STATE OF MISSOURI  
**DEPARTMENT OF NATURAL RESOURCES**

04/20/01

Subject/Title: MDNR0 Certification of SLAPS Wells - Issues Requiring Resolution Prior to Certification

location of weep holes on PW-39, similar for PW-40 and PW-41

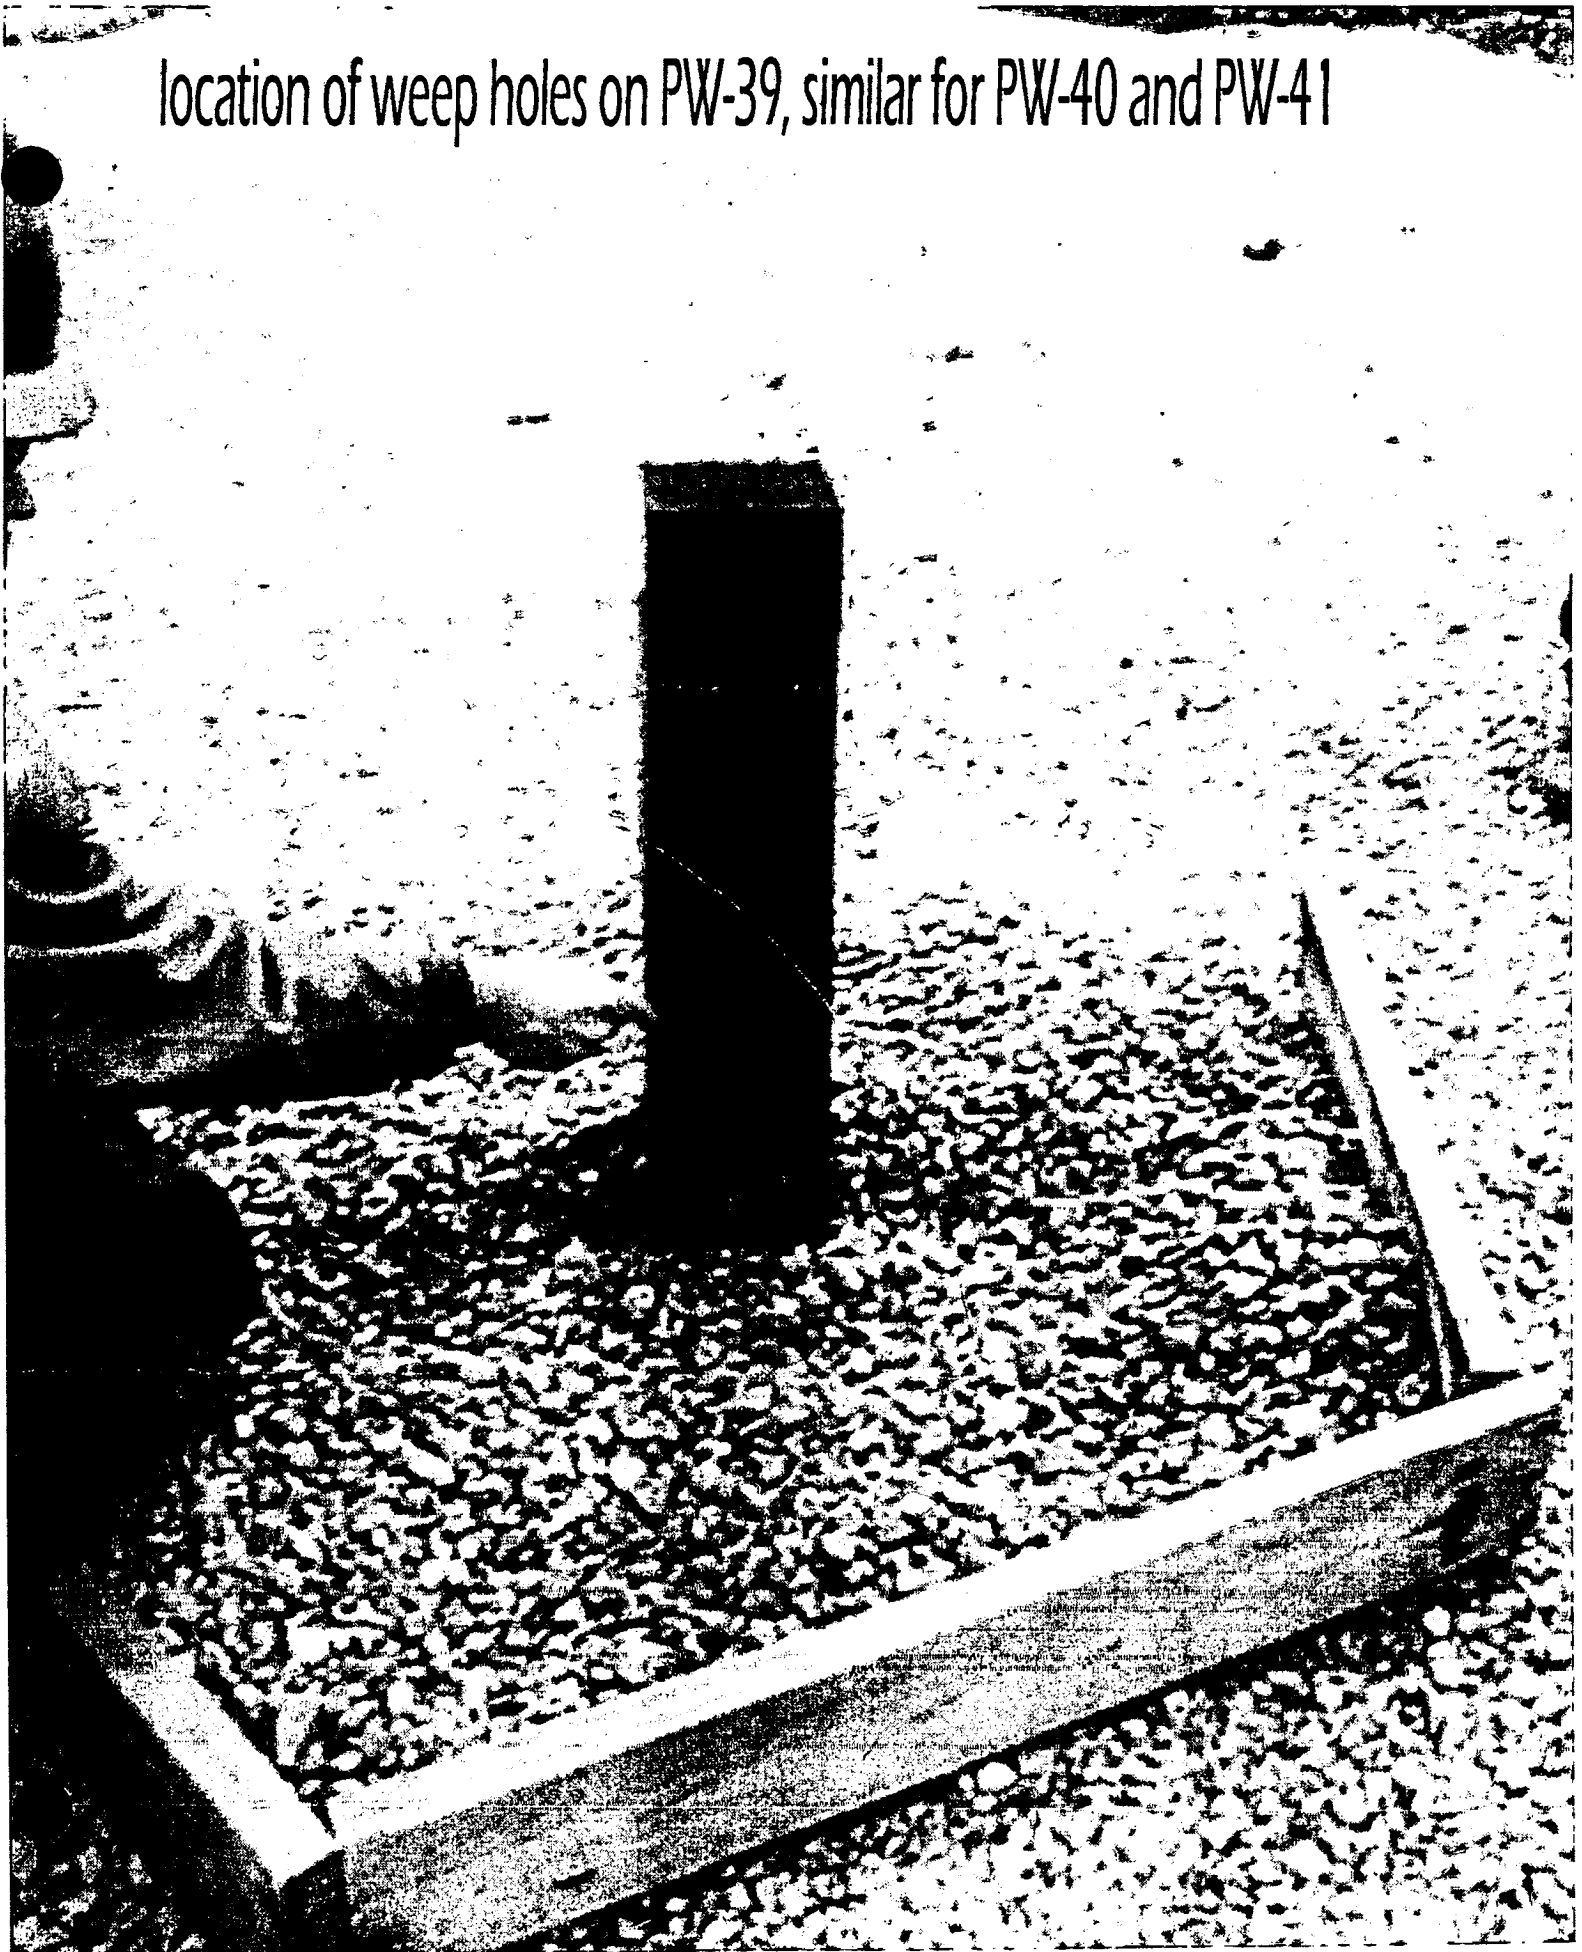
The concrete used in the surface completion of wells PW-39, PW-40 and PW-41 does not extend to the finished grade. I assume that the concrete for the surface completion and weep hole location were estimated as the finished grade apparently had not been placed at the completion point. The surface completion had been boxed in with lumber and large gravel was used to bring the area around the well to surface grade level (see accompanying photos).

For these three wells to be certified the concrete surface completion will have to be brought up to slightly above level with the current finished grade, with the concrete sloping slightly away from the protective casing. Also the current weep holes should be sealed with a waterproof sealant or welded over and new ones drilled in the proper location. Upon completion of the remediations, please contact this office and the wells will be certified.
